SOUTHERN CALIFORNIA RAPID TRANSIT DISTRICT METRO RAIL PROJECT

VALUE
ENGINEERING
STUDIES
MOS II

SUMMARY AND
FINAL REVIEW

Subject: Metro Rail Project
Value Engineering For MOS-II. Final Report

PROJECT Metro Rail VE #3 - Stations
 LOCATION Los Angeles, California
 SYSTEM Relocate Pocket Track & Add X-over

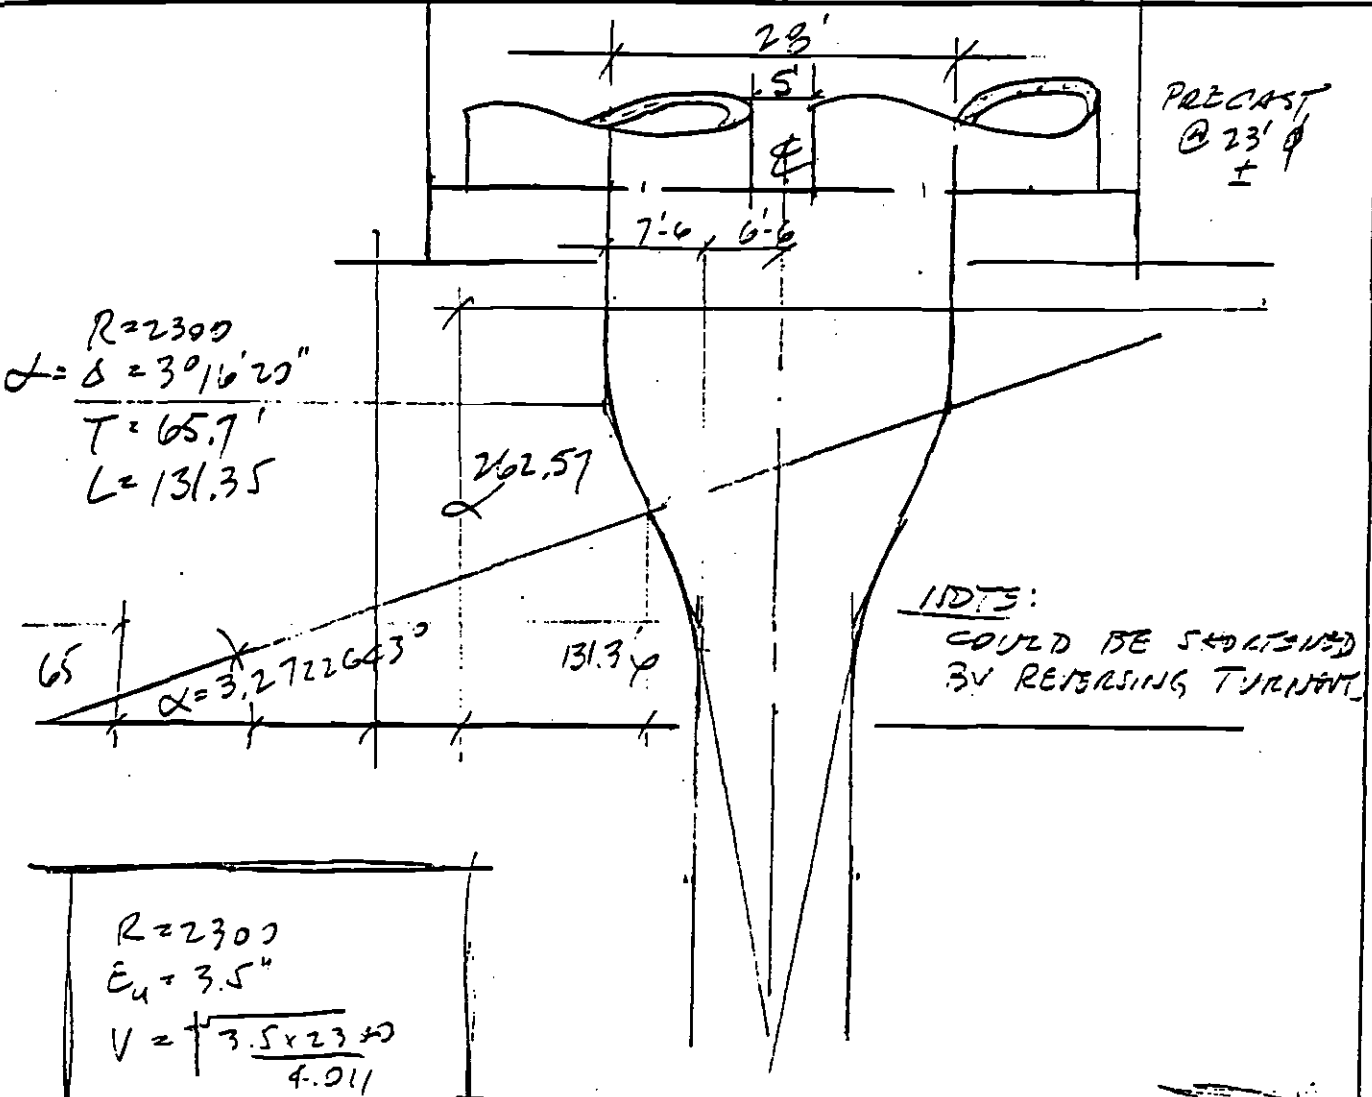
The pocket track/crossover functions are comparable to or better than that of the present design and unneeded space is saved with less costly construction for a narrow box. Although somewhat inconveniencing patrons when they have to change platforms, the advantages of the proposed design lie in its substantial savings in construction costs, reduced surface disruption and reduced construction time. The savings estimated is the combined total for MOS-II and MOS-III changes. The reduction in MOS-II construction scope is almost \$20 million; the increase in MOS-III scope is just under \$10 million.

$R=2300$
 $E_u = 3.5''$
 $V = \sqrt{\frac{3.5 \times 2300}{4.011}}$
 $= 44.7 \text{ MPH}$ MIN SPEED ACCEPTABLE ON MAIN LINE

@ 40 MPH $R = 1833.6'$

THEN $A = 3.6450067$
 $T = 58.66'$
 $L = 117.288'$
DISTANCE FROM PC TO PCC TO E.O. =
 $= 117.21 \times 2 = 234.42'$ of 262.57'

VEP # 3 STATIONS H/VINB REPLACES DOCKET TRACK W/ DBL X-OVER	JOB No.	SHEET No.
	DESIGNED BY	DATE 10/25/19
	APPROVED

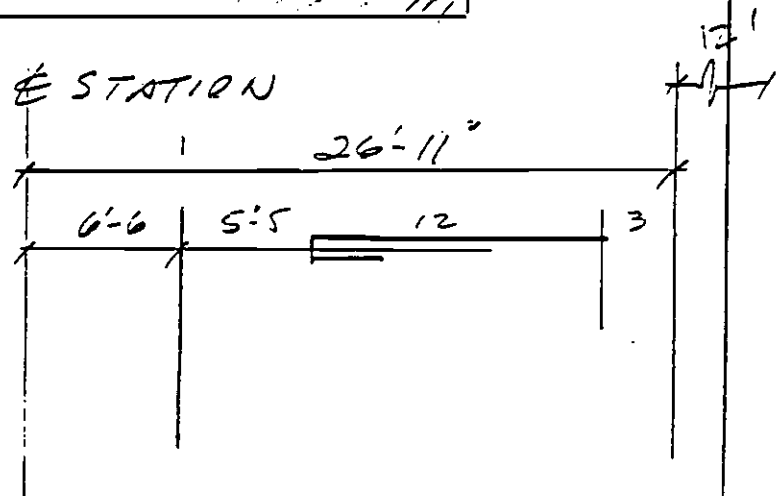
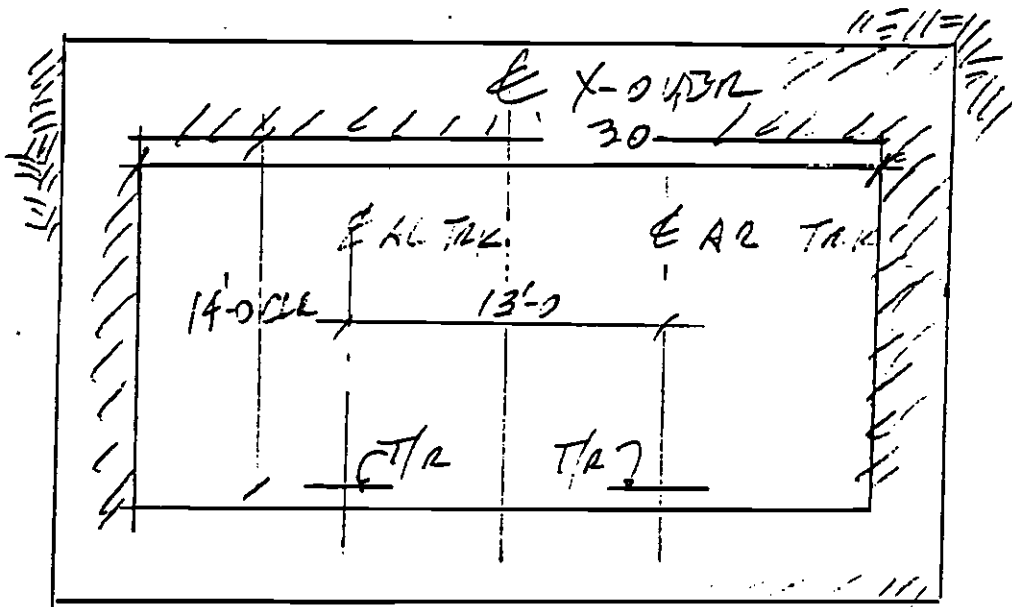
$26'-11" \times 2 = 53' 10" + 24 = \underline{77'-10"} \text{ WIDTH}$
 $cf = 51.33'$

#10 3PC X-OVER PS TO PS = 292.5' (14' C.C.)

VALUE ENGINEERING PROPOSAL #10 (Study No. 3):

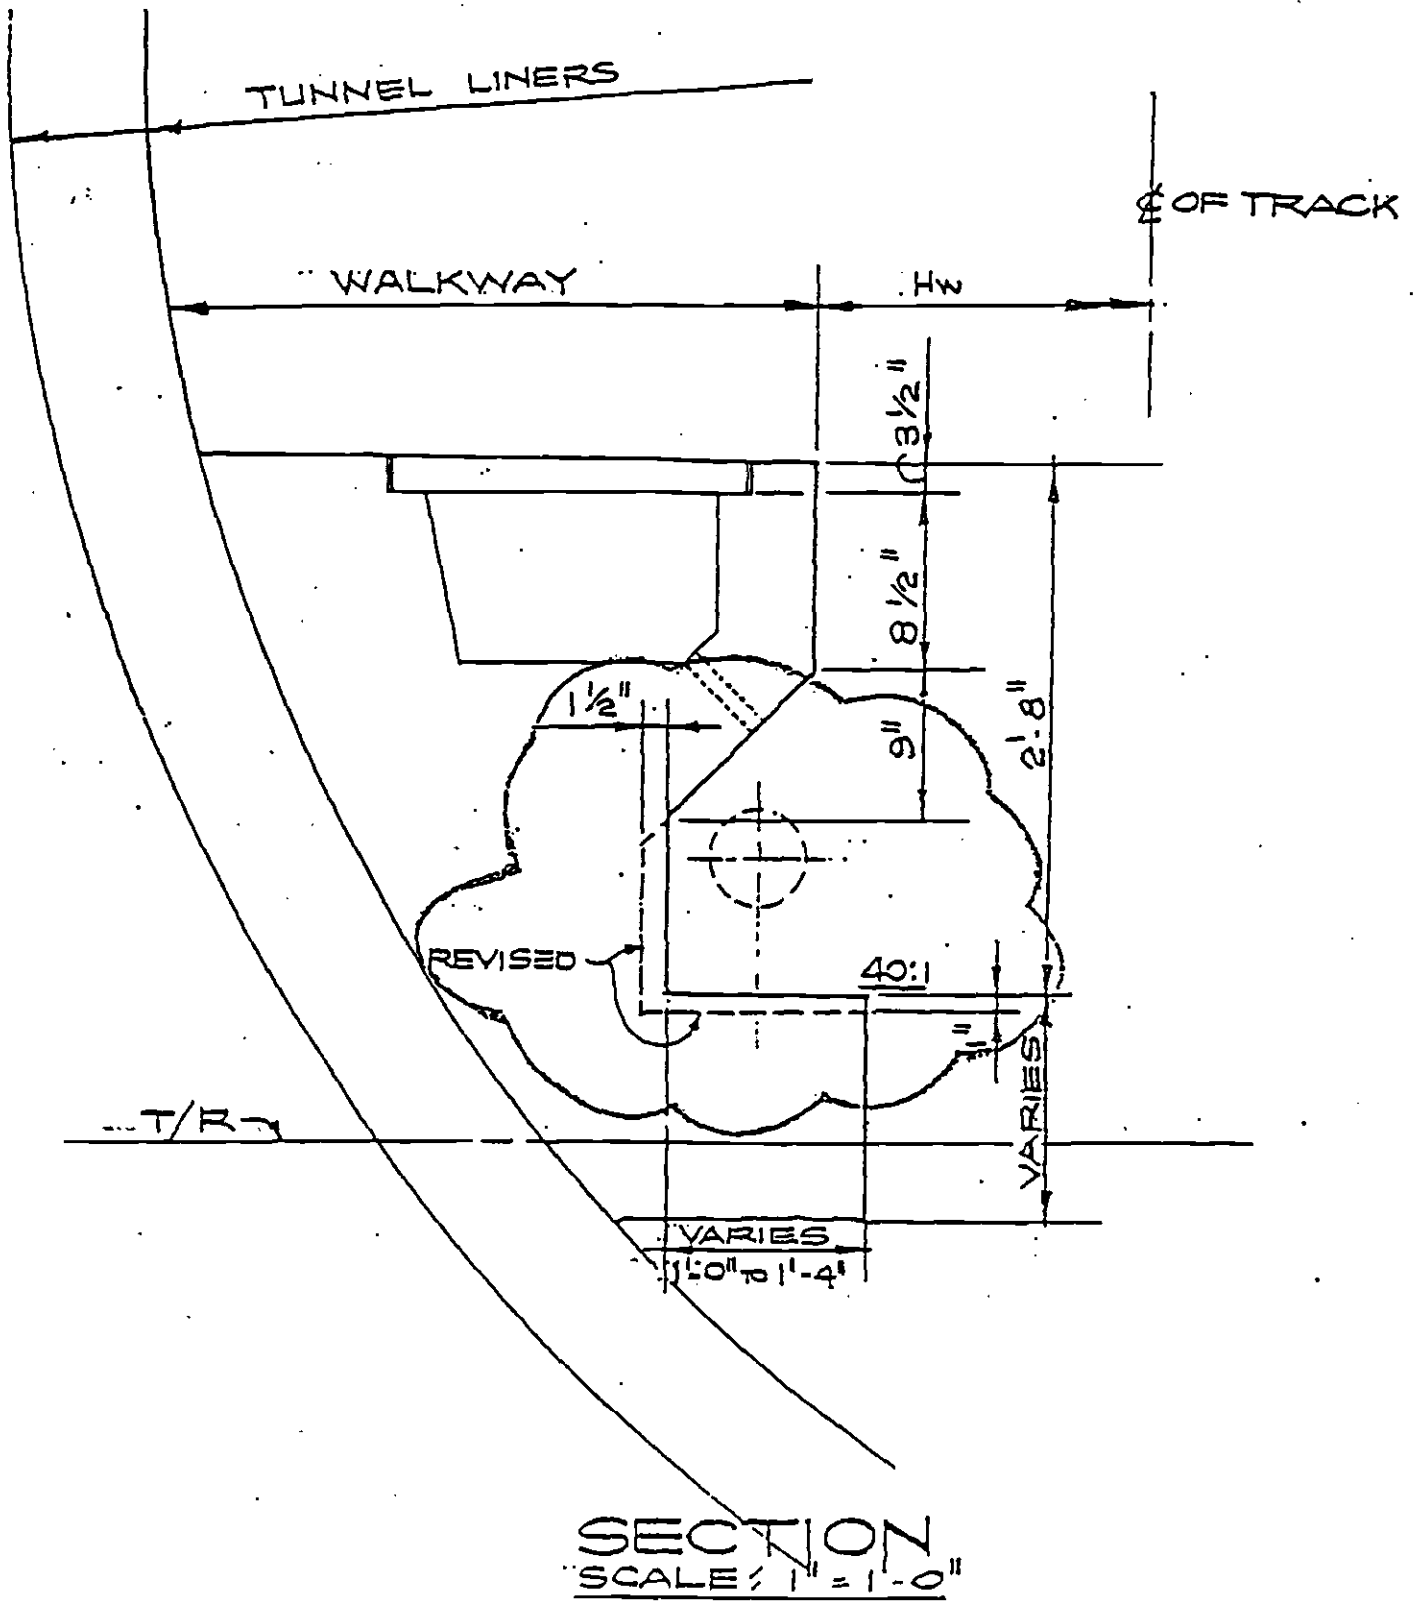
The Environmental Control System Report (August 1985) addressed the elimination of station Supply Air System, and concluded that station temperature will exceed 90 F when the outside air is 84 F at three minute headway, LRDS, if station supply air system is deleted. There are many days in a year when the outdoor temperature exceeds 84 F, which will result in even higher system temperature if the station supply air system is not installed. When the headway is further reduced it is predicted that the station temperature will range from 92 F to 104 F. At that time mechanical cooling will be required to maintain reasonable station environment, which is expected in a modern transit system. The station environment prediction is based on many assumptions including the effectiveness of the underplatform exhaust system,

which may not be as effective as assumed resulting in higher temperature, and requiring mechanical refrigeration at longer headways.

Proposal No. 1 - Station Depth

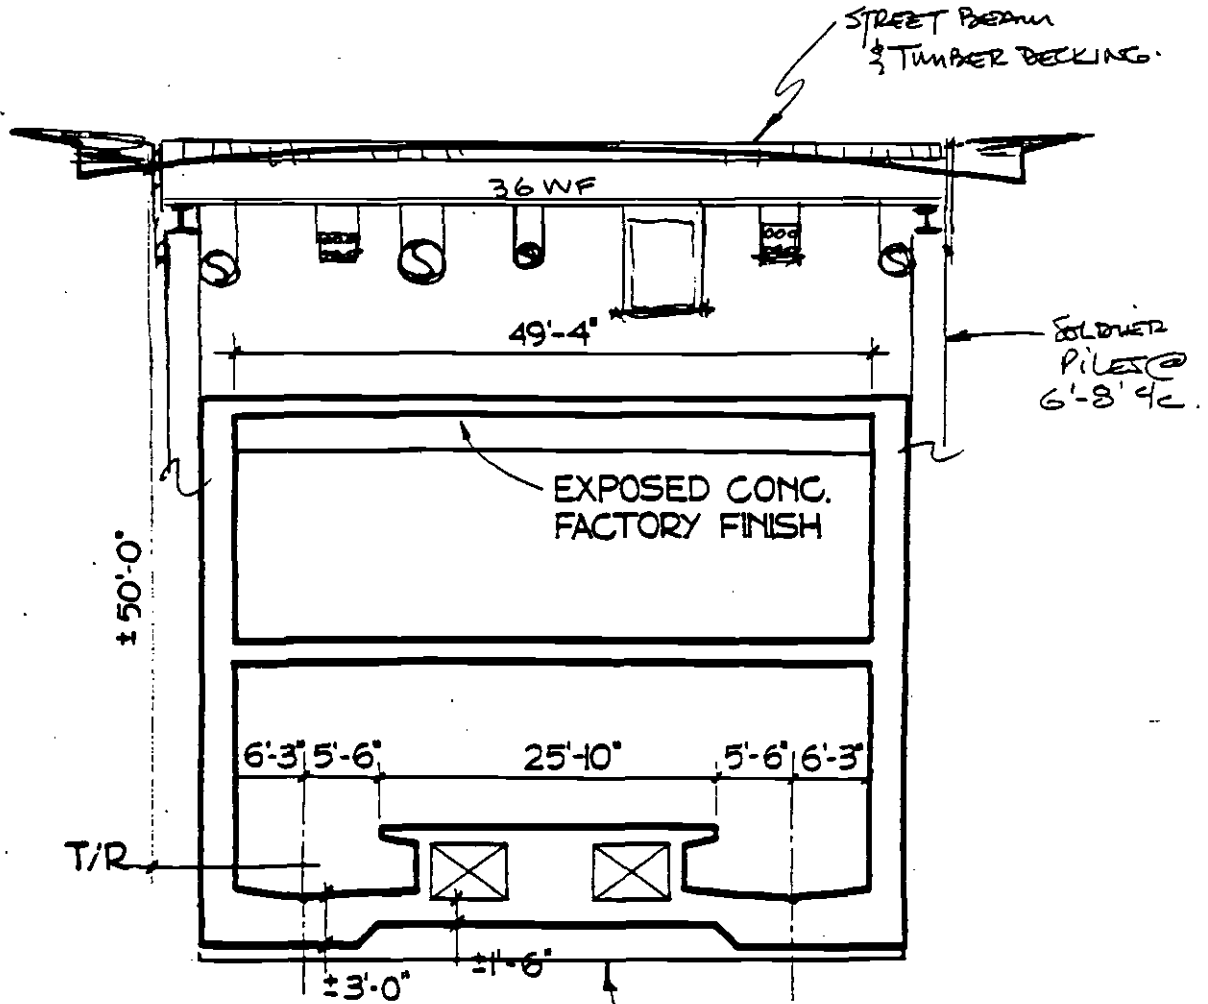
- o A sketch of the control dimensions of the station box has been developed to indicate the current limiting critical dimensions. (See page 2).
- o Reduction of the overall box depth is only possible if a number of standard design features which address, air handling, methane gas venting, elevator clearances, etc., are reconsidered in the Phase II Design.
- o MRTC will consider the minimal structure depth in each station. However, such factors as negative buoyancy can add additional structure depth and wall thickness.

Proposal No. 4 - Station Foundation

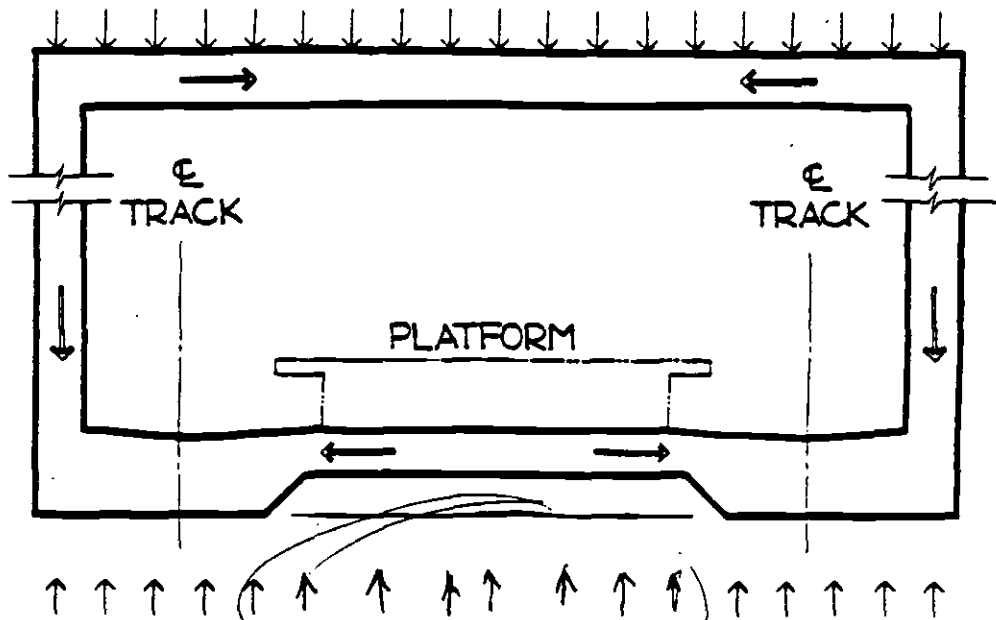
- o MRTC further notes that the three stations on Vermont Avenue will be designed to a final water table elevation above the roof of the station vault. The Hollywood corridor stations will encounter a hydraulic head from invert elevation to mezzanine elevation. In each case hydrostatic uplift forces are considered uniform across the underside of structure.
- o The attached station foundations - proposed design sketch (page #5) is marked up to show the shortcoming of the proposed station vault cross-section.
- o We estimate that the projected savings is, in fact, an additional cost of \$2. to \$3 million for the column - free roof design.

TRIAL 1 - SKETCH OF TUNNEL TO NARROW T.C. CROSSOVER	JOB No.	SHEET No. 15-1
	DESIGNED BY S.J	DATE Dec 1989
	APPROVED

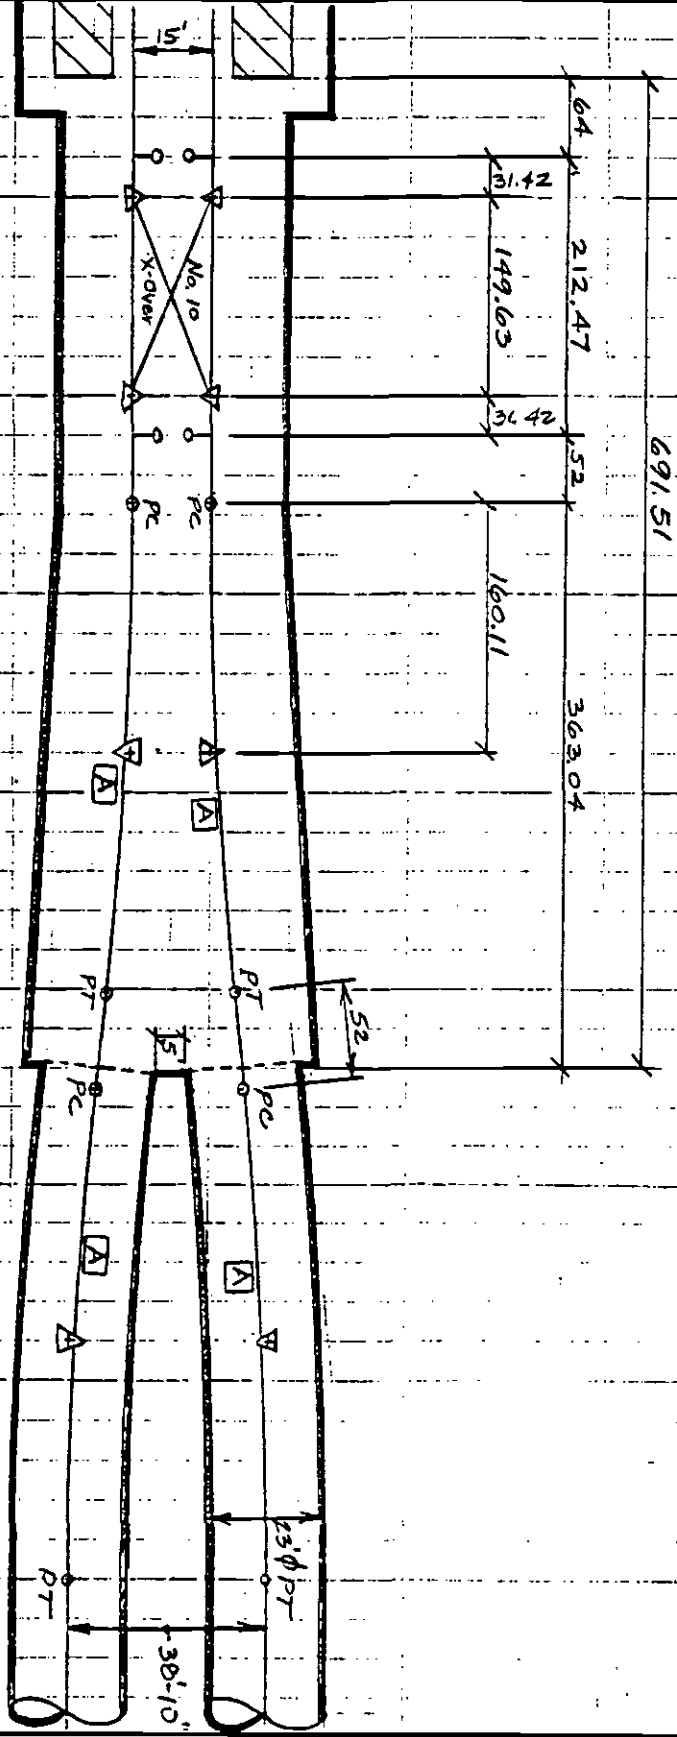
$R = 10,000'$ ($D = 200^\circ 34' 23''$)
 $\theta = 1^\circ 50' 04.6''$
 $T = 160.11'$
 $L = 320.20'$
 $V = 45 \text{ mph}$
 $E_s = 0$
 $E_w = 1''$
